SITE AND DEVELOPMENT PLAN AND SPECIAL EXCEPTION STAFF REPORT 7-ELEVEN

February 19, 2019
18-07SP
18-07SE

PETITION NOS.: 18-07SP and 18-07SE

REQUEST: Site and Development Plan for the redevelopment of an automotive convenience center to include a 2,958 sq. ft. retail building and a canopy over 12 new re-fueling stations.

PROPOSED SITE PLAN

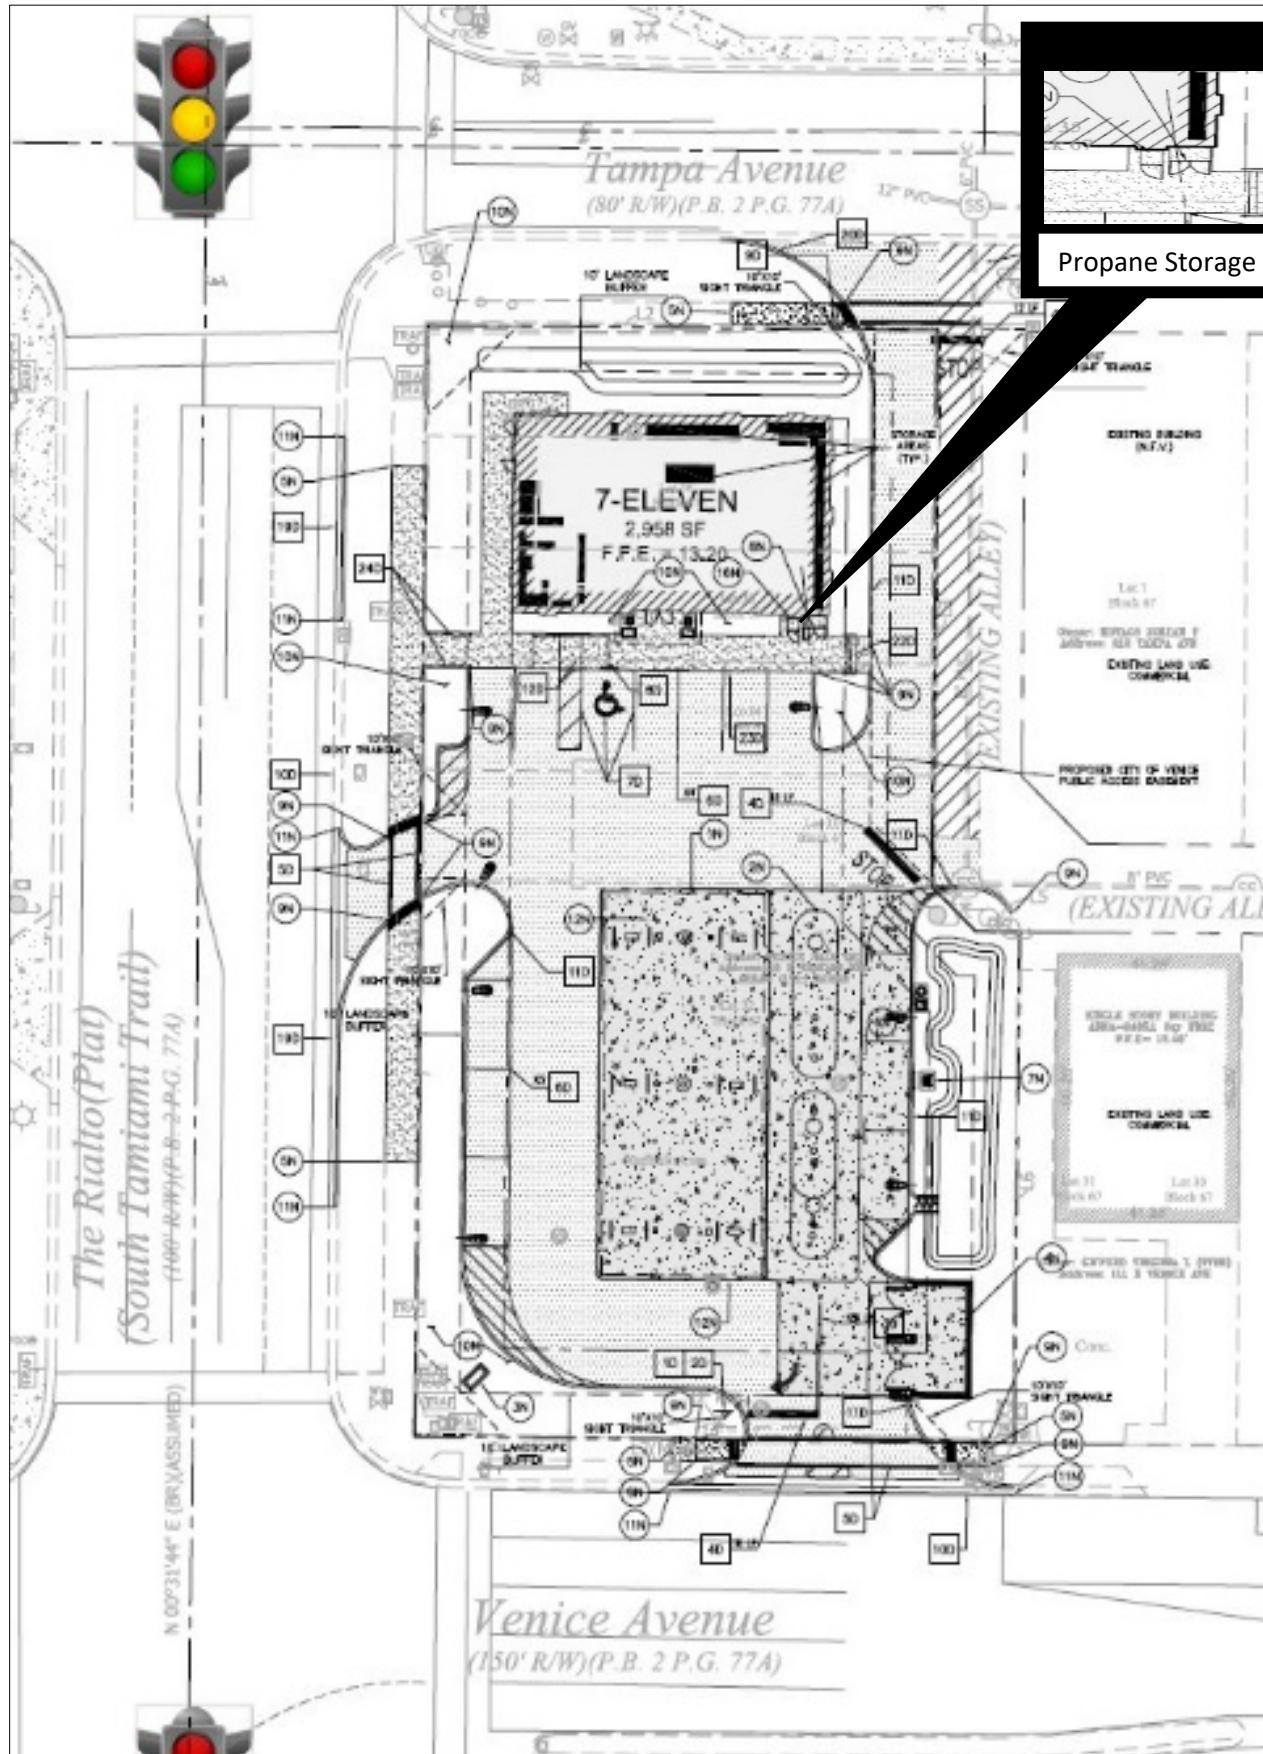
Staff Comment: *In addition to fuel tanker vehicles, there will also be regular delivery trucks accessing the property.*

Staff Comment: *The proposed special exception is for outdoor display of propane gas tanks which has become a common product/service of convenience stores.*
